DEPARTMENT OF THE ARMY  
KANSAS CITY DISTRICT, CORPS OF ENGINEERS  
700 FEDERAL BUILDING  
KANSAS CITY, MISSOURI 64106-2896

The U.S. Army Corps of Engineers, Kansas City District is pleased to submit two hard copies and one electronic copy of the Final Decision Document for Operable Unit 1 (OU-1) at the St. Louis Ordnance Plant, Former Hanley Area, in St. Louis, Missouri. The enclosed copies have been signed by the U.S. Army Environmental Command. Additional copies have been distributed as noted below.

**Responses to USEPA Comments on the Draft Final Decision  
Document for the St. Louis Ordnance Plant, Former Hanley Area**

Responses to MDNR Comments on the Draft Final Decision  
Document for the St. Louis Ordnance Plant, Former Hanley Area

**FIGURE 2-4**  
**GEOLOGIC CROSS - SECTION A-A'**

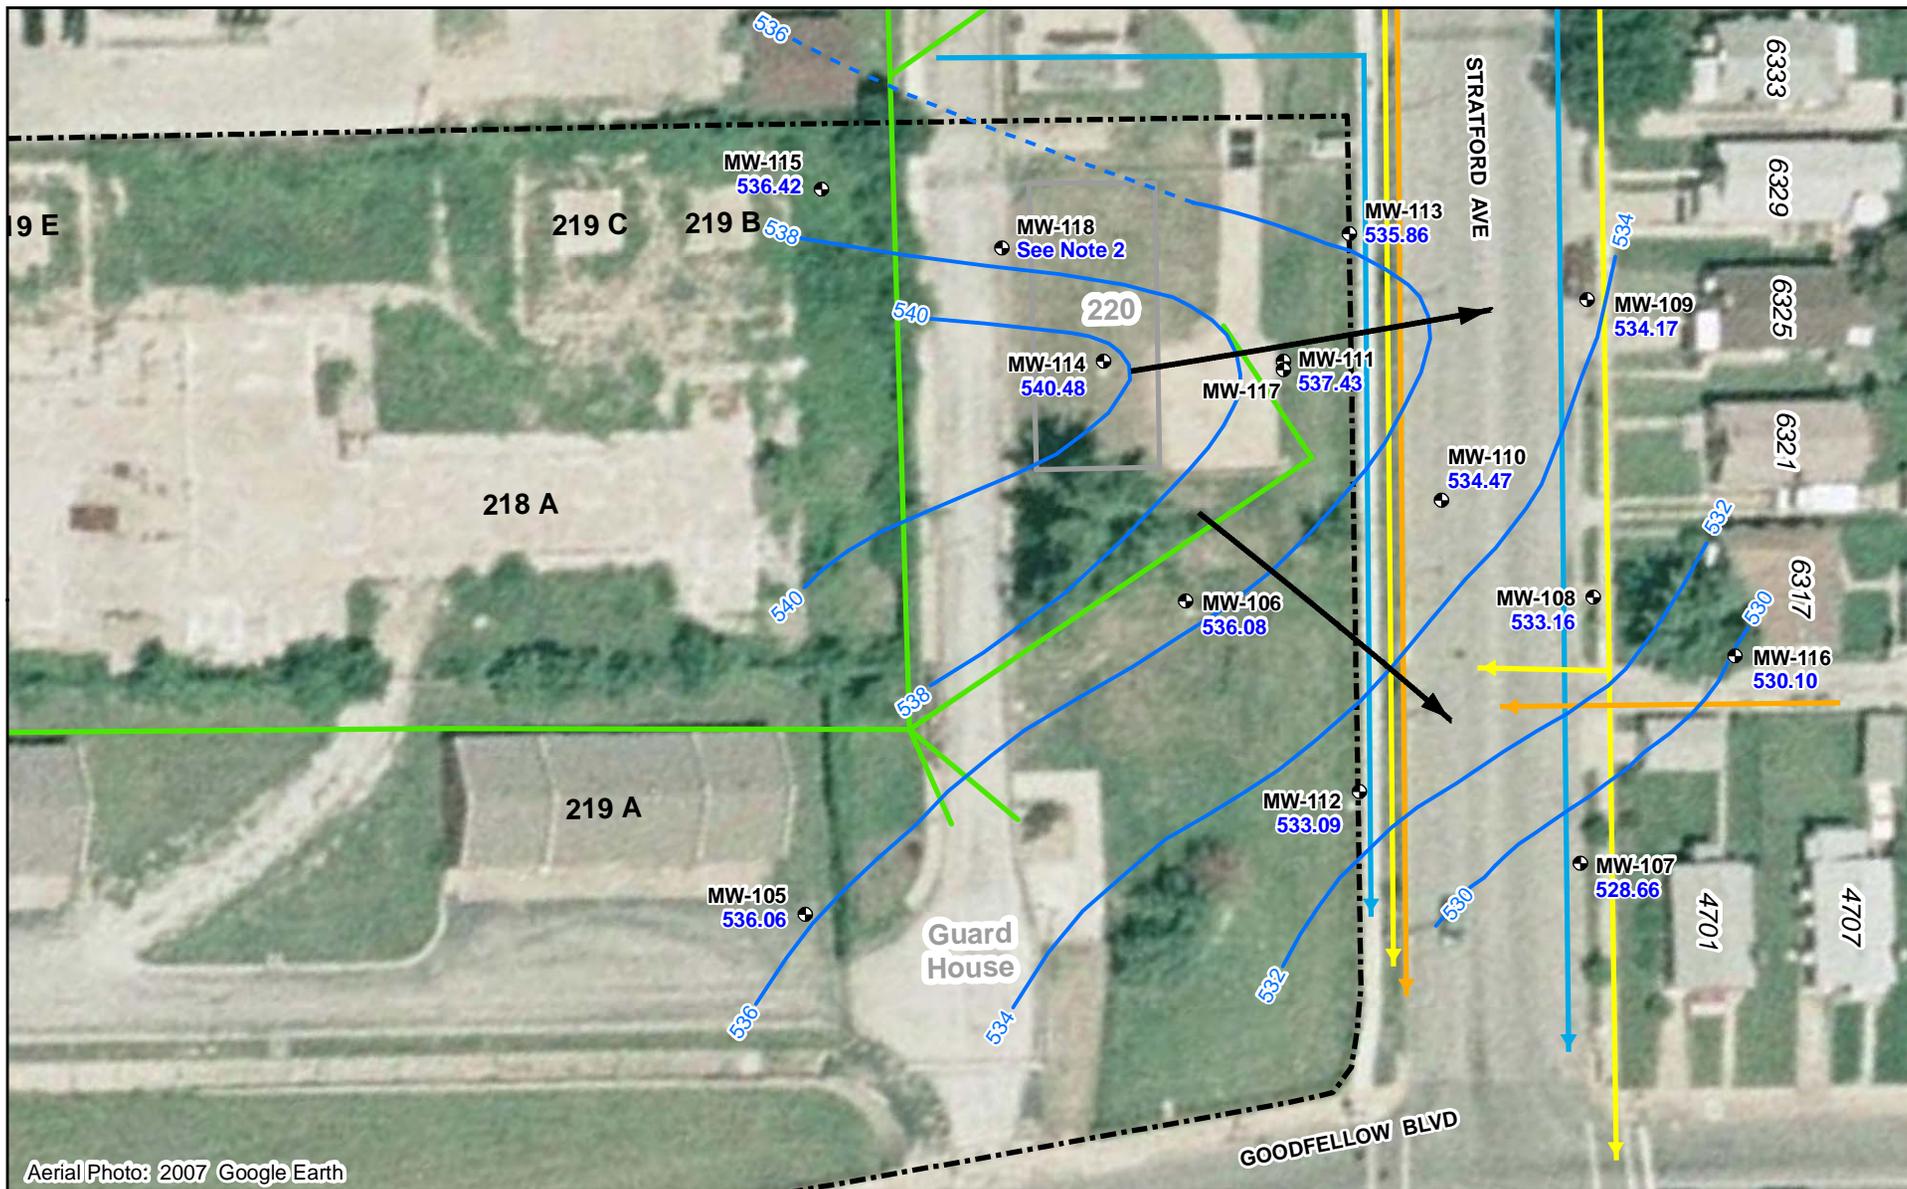
Figure 2-4: Please add an explanation of the USCS classifications to the legend. Please include a notation for the screened intervals in the groundwater monitoring wells.

Figure 2-4 will be revised to include the meaning of the USCS terms "CL" (lean clay), "CH" (fat clay), and "ML" (silt). In addition, the symbol for typical monitoring well screens will be provided in the Legend.

**FIGURE 2-14**  
**LAND USE CONTROL BOUNDARIES**  
 St. Louis Ordnance Plant  
 Former Hanley Area  
 St. Louis, Missouri  
**CH2MHILL**

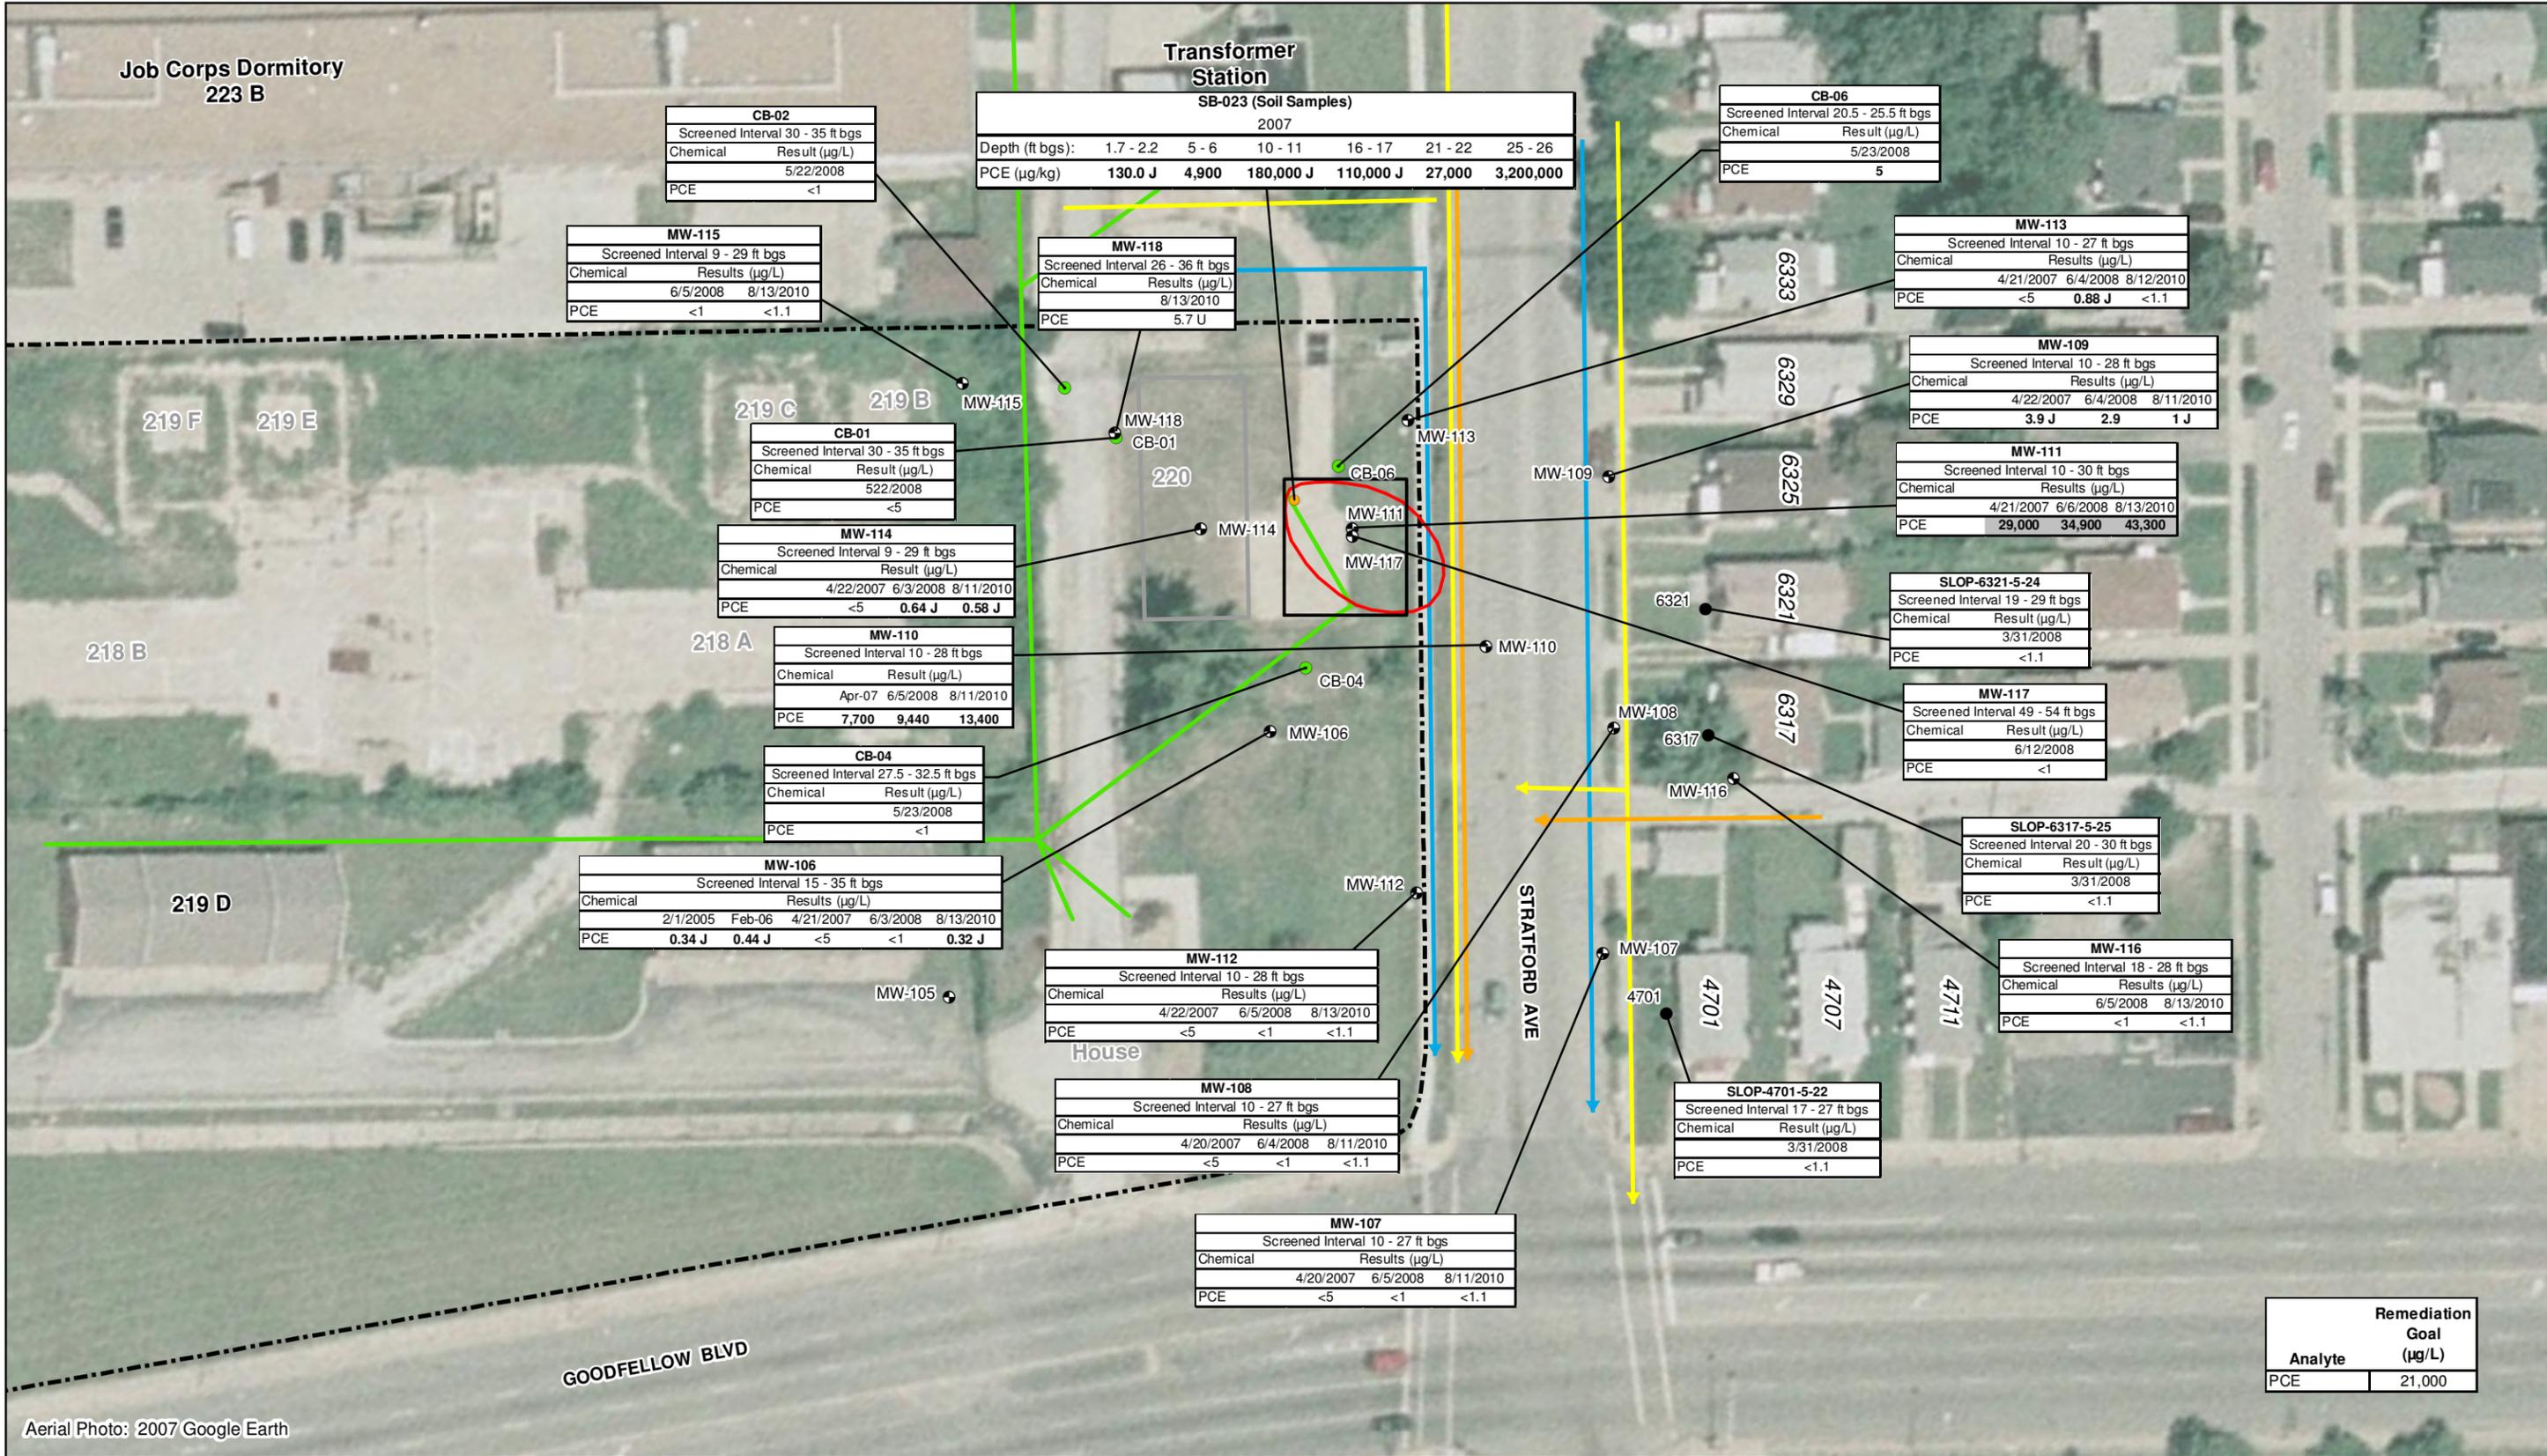
- a. The VI evaluation discussions should reference the fall 2010 meeting between USACE, MDNR, USEPA and the other project stakeholders regarding further VI activities, including additional indoor air sampling and subslab sampling.
- b. Based on the language of the NCP and the ROD guidance, the VI analysis and decision should be documented in separate ROD as another operable unit. Modify sections 2.9.2.2 and 2.12.2.3 to include this language.
- c. If action is required, then remedial action objectives, an evaluation of alternatives based on the nine criteria specified in the ROD guidance, public participation and land use controls for VI will need to be discussed the modified ROD. Specifically, LUCs will need to cover the following:
  - i. Risk exposure and reasonably anticipated land uses

- ii. Risks necessitating the LUCs
- iii. The logic behind selecting the LUCs
- iv. Add language on the duration of the LUC, such as "Land Use Controls will be maintained until the concentrations of the vapors or groundwater are at the levels to allow for unrestricted use and exposure."

LUCs are shown in Figure 2-14, titled Land Use Control Boundaries.
